AVN-20220701.0 TEB0911 RTC does not work

Company	Trenz Electronic GmbH
AVN Number	AVN-20220701.0
Title	AVN-202207010.0 TEB0911 RTC does not work
Subject	Information about RTC usage
Issue Date	2022-07-01

Procedure to fix RTC issue

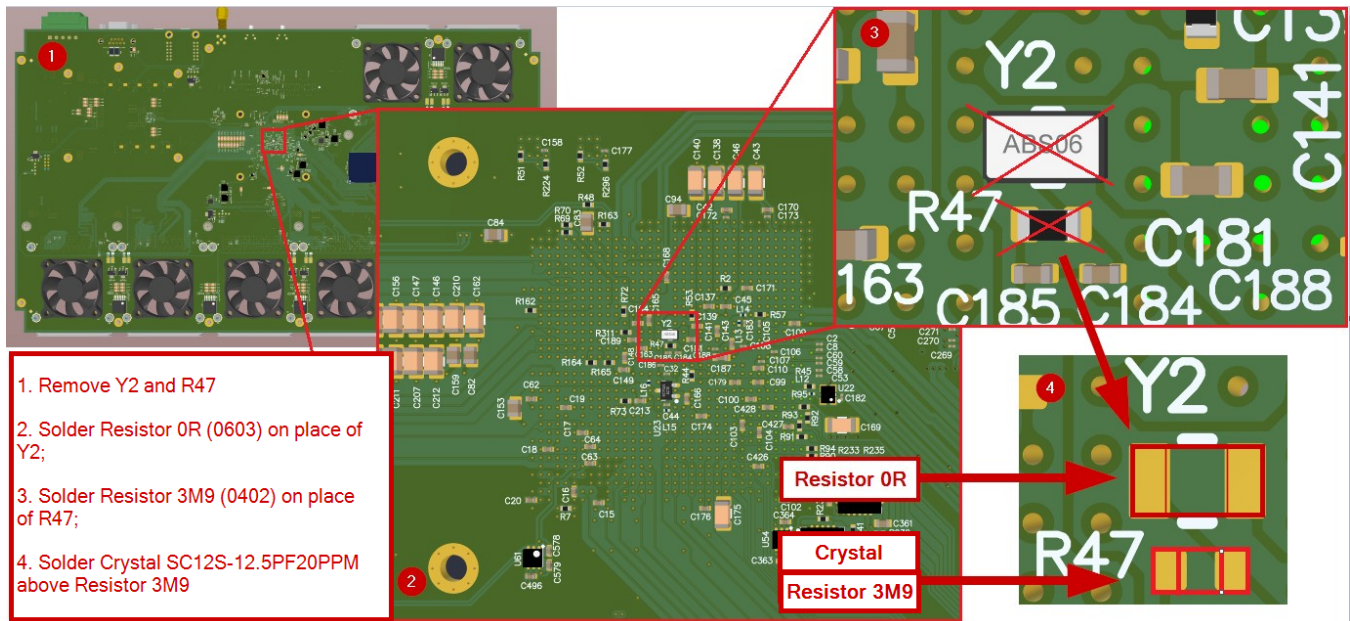
The HW wiring for the RTC is incorrect. This leads to the fact that the RTC initializes, but the time does not change.

Problem can be solved with following HW changes:

1. Remove Y2 and R47
2. Solder Resistor 0R (0603) on place of Y2
3. Solder Resistor 3M9 (0402) on place of R47
4. Solder Crystal SC12S-12.5PF20PPM above Resistor 3M9
